HISTORIC AND DESIGN REVIEW COMMISSION

October 06, 2021

HDRC CASE NO: 2021-469
ADDRESS: 314 NORTH DR
LEGAL DESCRIPTION: NCB 7014 BLK LOT E 12.5 FT OF 27 & W 44.5 FT OF 28
ZONING: R-6, H
CITY COUNCIL DIST.: 7
DISTRICT: Monticello Park Historic District
APPLICANT: Rudy Davila/DAVILA CONCRETE CONTRACTORS
OWNER: BRITTNEY ESPINOZA/ESPINOZA BRITTNEY RYANNE &
TYPE OF WORK: Installation of a driveway, curb cut, approach and on-site walkways
APPLICATION RECEIVED: September 14, 2021
60-DAY REVIEW: Not applicable due to City Council Emergency Orders
CASE MANAGER: Edward Hall

The applicant is requesting a Certificate of Appropriateness for approval to install a new curb cut, driveway apron, driveway and walkway on site at 314 North, located within the Monticello Park Historic District.

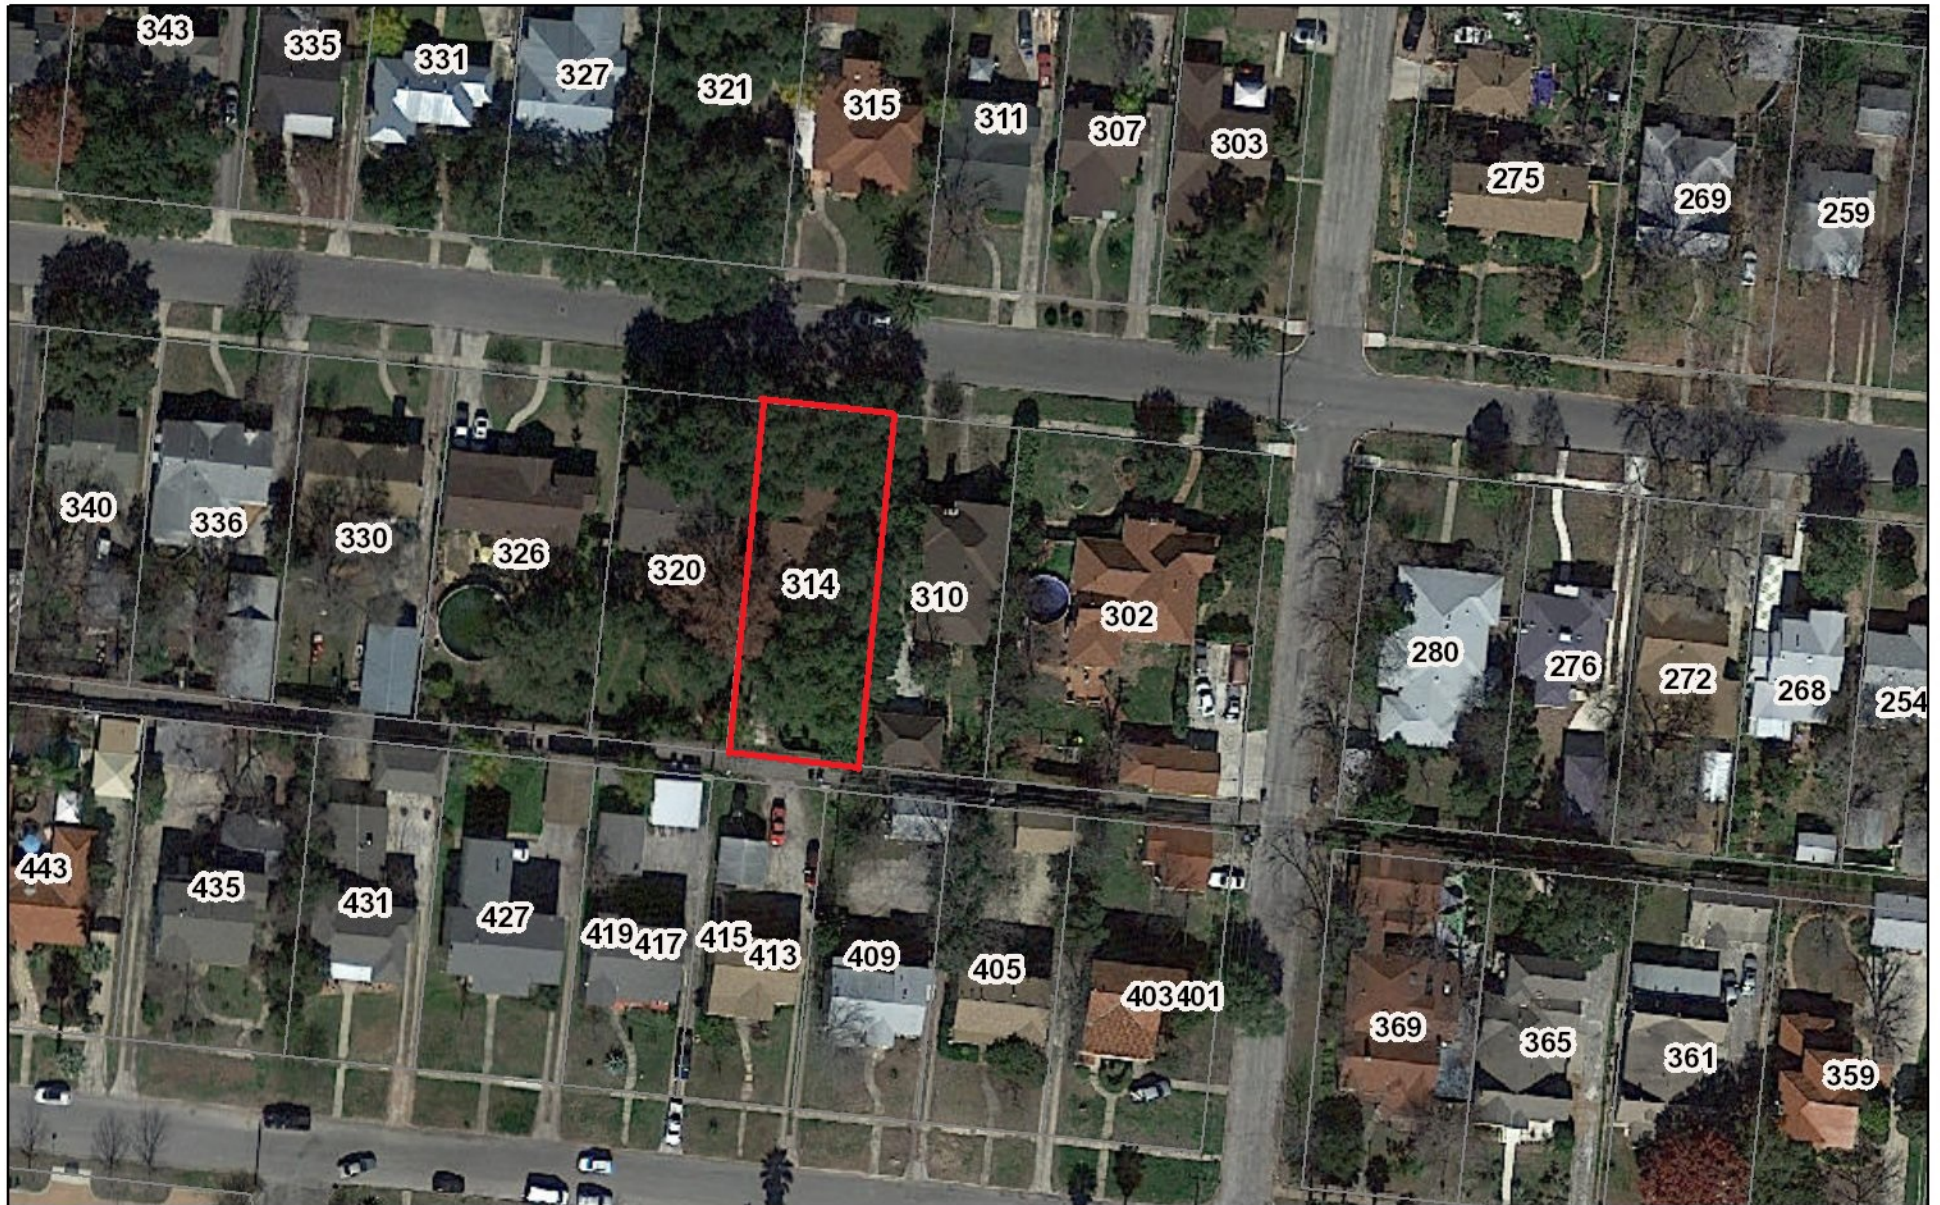
- c. DRIVEWAY – The applicant has proposed a driveway with a curved profile resulting a parking being located in front of a portion of the historic structure that is setback from the primary façade. The Guidelines for Site Elements 5.B.i., new driveways should feature a similar configuration as those found historically within the district in regards to their materials, width and design. Driveways found historically within the Monticello Park Historic District feature straight profiles with either ribbon strip or full concrete configurations. Historic driveways are approximately ten (10) feet in width. Staff finds the proposed driveway to be inconsistent with the Guidelines. Staff finds that a straight driveway that does not exceed ten (10) feet in width would be appropriate. While the driveway would terminate in front of the house, the section of the house where it would terminate is setback from the primary façade. Staff finds this terminating point to be appropriate.

- d. WALKWAY – The applicant has proposed a walkway within the front yard to feature concrete paving to lead from the proposed driveway to the existing front walkway. Staff finds the proposed walkway to be appropriate.

Staff recommends approval based on findings c and d with the following stipulations:

- i. That the proposed driveway feature a straight profile and a width that does not exceed ten (10) feet.
- ii. That the proposed curb cut and driveway apron be consistent with those found historically on the block in regards to profile and width.
